RE: NOTICE OF DEFICIENCY (NOD) FOR OPERABLE UNIT (OU) 1079 PLAN

Notice of Deficiency Response for OU 1079 RFI Work Plan

The following comments have been drafted in response to the Notice of Deficiency received by the DOE from EPA Region VI on October 5, 1992. The responses follow the format and sequence of the List of Deficiencies.

Figure 5.1-3 TA-10 surface sampling locations (modified from Mayfield et al. 1979, 06-0041).

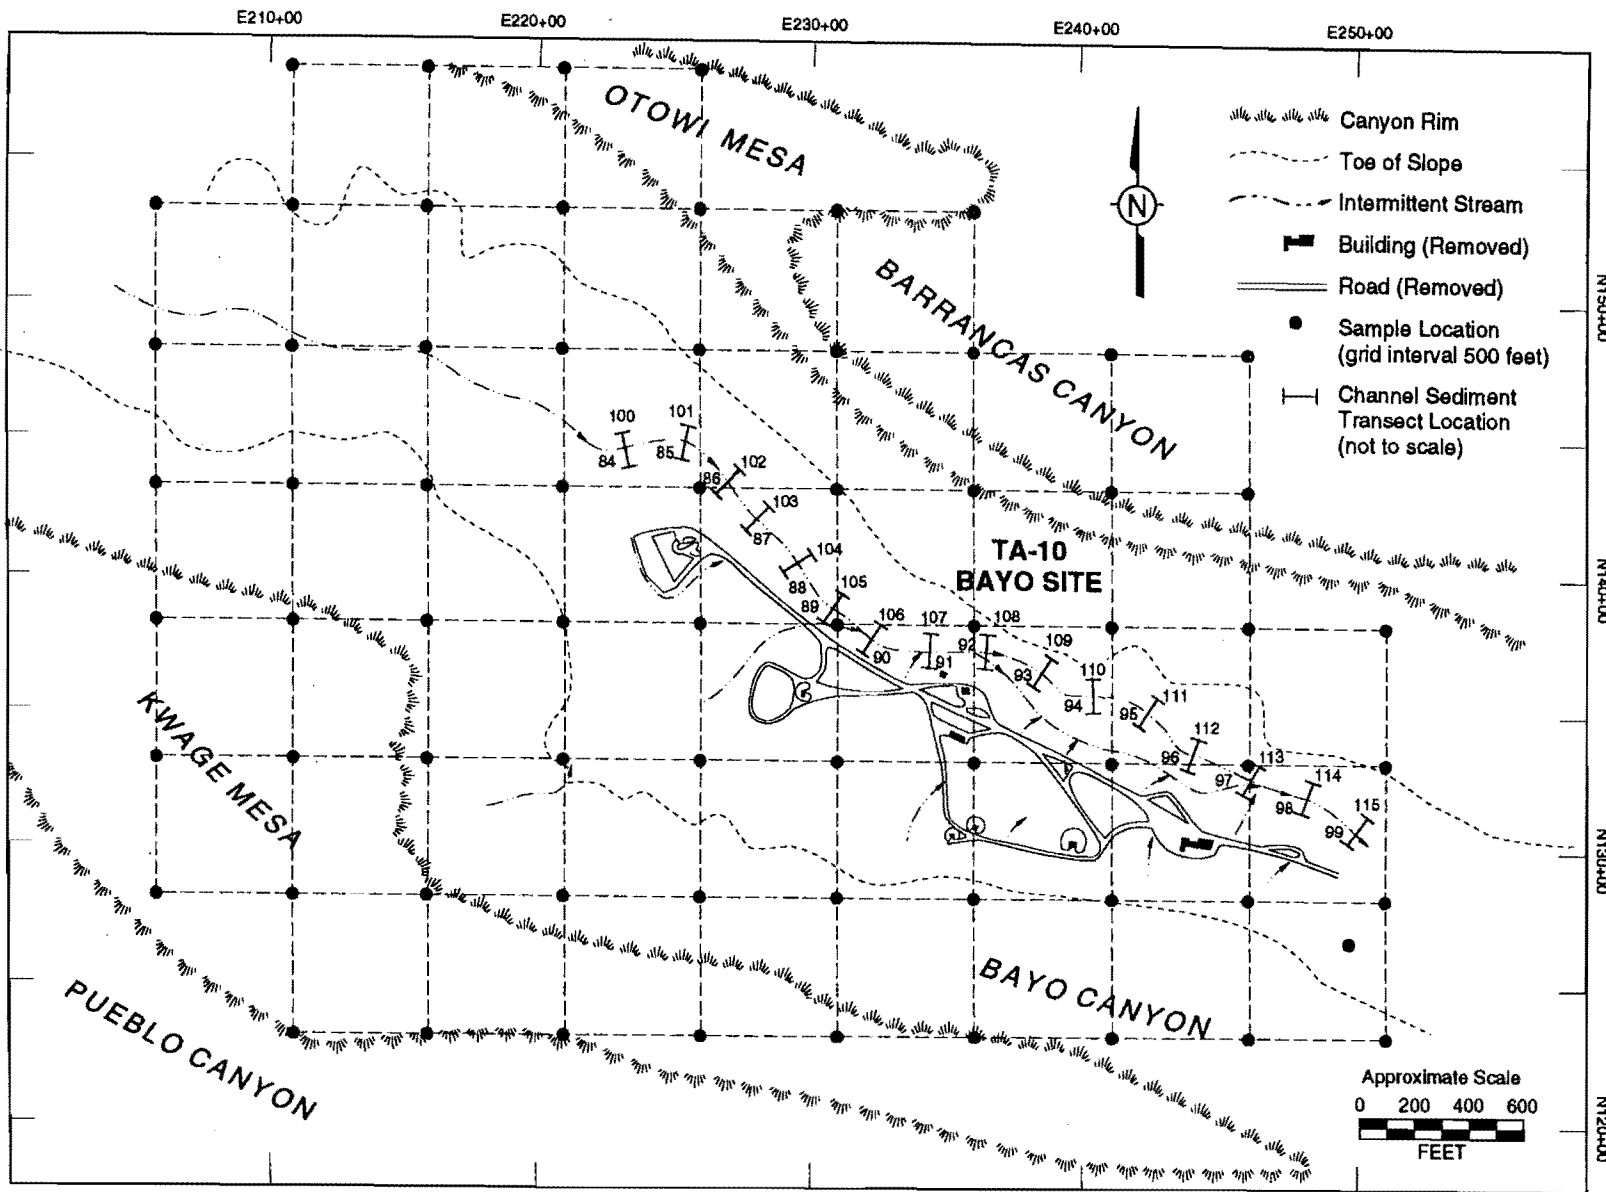
5.1.2.6.2 Sample Collection - TA-10 Channel Sediments p. 5-21 - The Problem Statement (5.1.2.1 on page 5-15) indicates that it is expected that surface contaminants from anywhere in the TA-10 site will be concentrated in the Bayo Canyon channel. Some samples will be collected from the stream as part of this work plan and other additional samples may be collected as part of the Canyons RFI work plan. As part of a thorough investigation of this OU 1079, the channel sediments should be adequately sampled. Analysis of these samples should be for Appendix VIII constituents. The sample transects indicated should be extended further downstream to incorporate any runoff from the liquid disposal systems near the radiochemistry laboratory. LANL should sample at least two more downstream transects.

- 5.1.2.6.2 The sampling plan for the Firing Site SWMU aggregate, which includes the stream channel transect sampling, was focused on surface sampling for contamination constituents generated during the test firing operations, i.e. lead, beryllium, barium and explosive constituents. Characterizing the potential contamination from the liquid disposal system is included in a separate sampling plan focused on subsurface investigations. Although the potential for subsurface contamination to reach the surface seems small, we will add two downstream transects to enhance the completeness of this particular sampling plan relative to the potential for the liquid disposal system to have contributed to channel contamination. The sample analysis for the samples collected from these additional transects, as well as the transect adjacent to the liquid disposal system, will be analyzed for TAL metals, explosive constituents, and Semivolatiles. The analysis of the upstream transect samples will remain as originally planned. These changes in the Channel Sediment Sampling plan are shown in the revised version of figure 5.1-3 and table 5.1-4, attached.

Figure 8.1-6. TA-45 transect sampling locations.

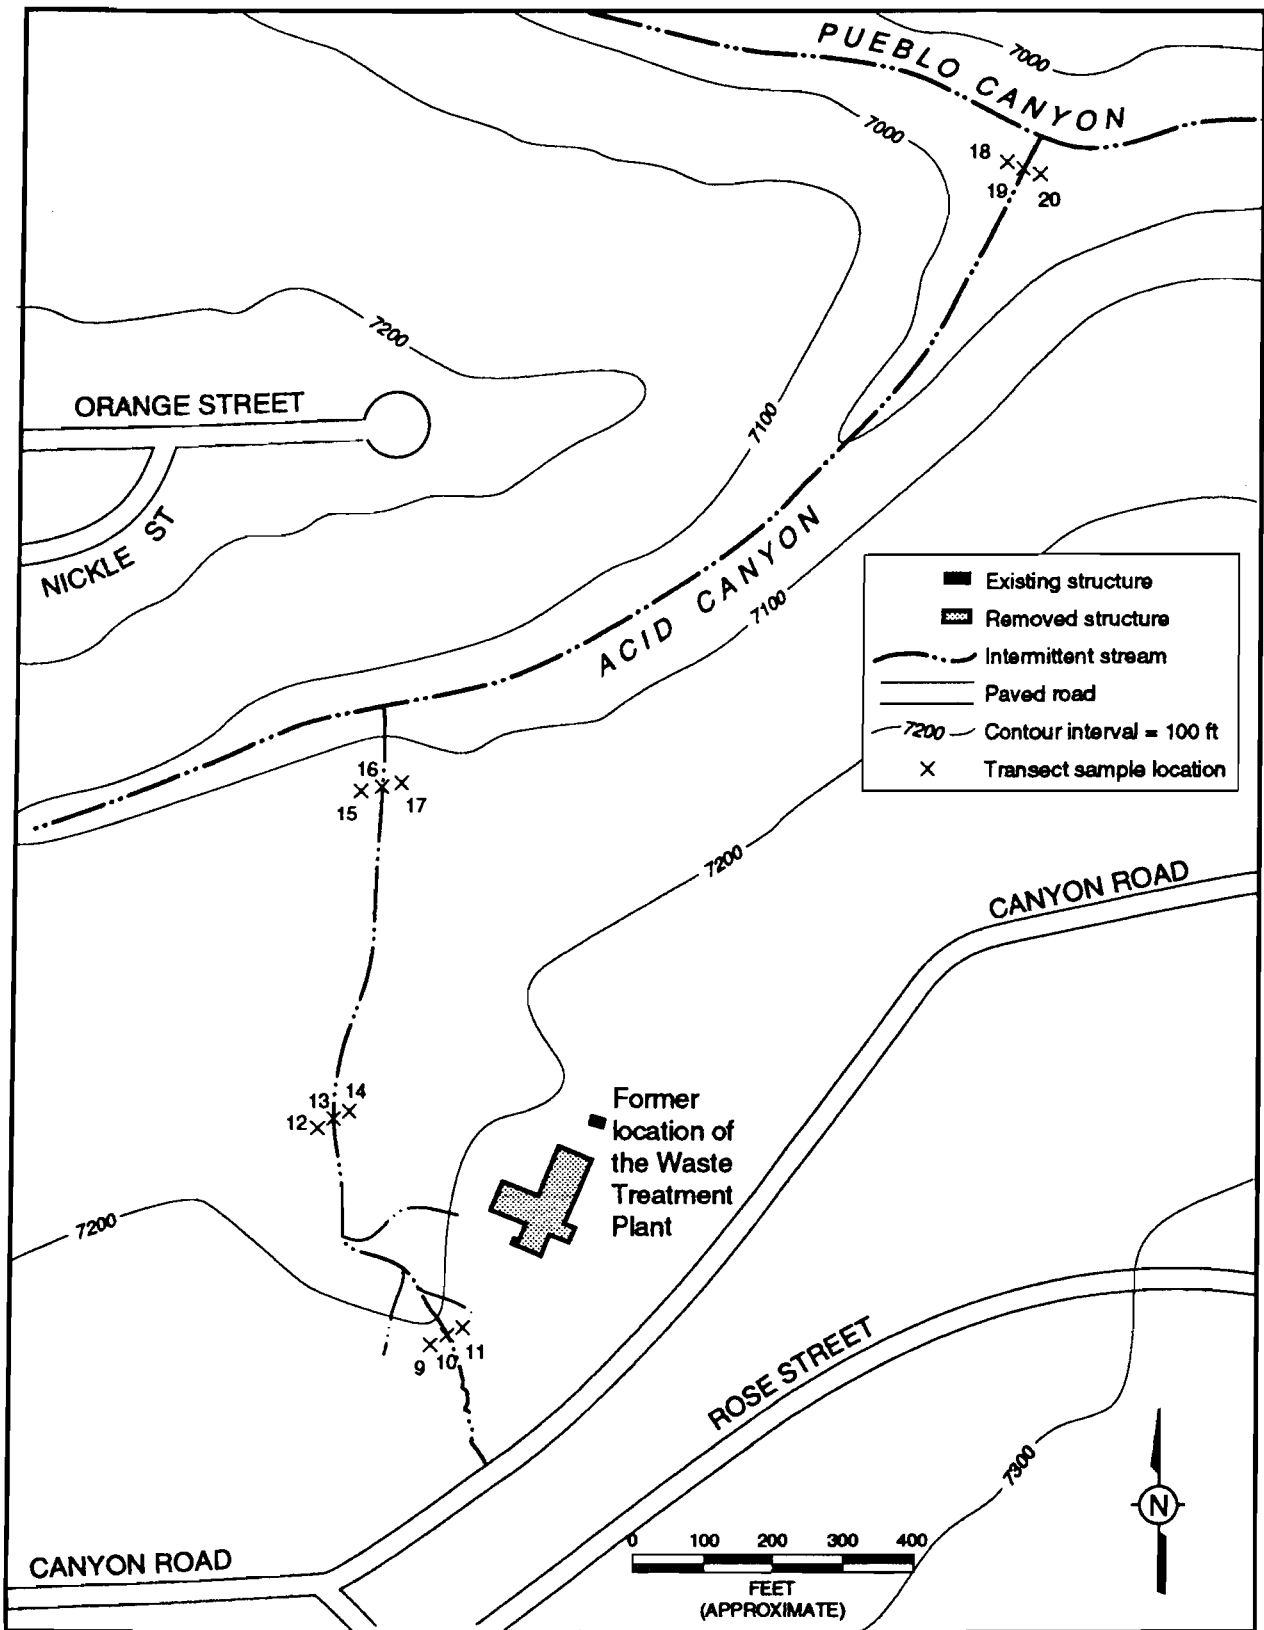
8.1.6 Sampling Plan - SWMU 1-002 Untreated Industrial Waste Line p. 8-12 - The sampling locations in Figure 8.1-3 do not show all the locations for the transects proposed for the Acid Canyon to Pueblo Canyon surface samples, and it is unclear if each of the three samples collected at the transect will be analyzed for TAL metals and semivolatile organics, explosives and volatiles. Please elaborate on the transect sampling and provide a figure depicting sampling locations.

8.1.6 We have included an additional figure (8.1-6) with the appropriate scale to show the locations of the two transects not shown in figure 8.1-3 on page 8-14. Also, the specifics of the planned analysis for these particular samples (SWMU 1.002 samples 9-20) are given in Table 8.7-1, and consist of TAL Metals, Semivolatiles (SW-8720), and Volatiles (SW-8240). Note that the samples will be analyzed for Volatiles only if field screening gives a positive result.
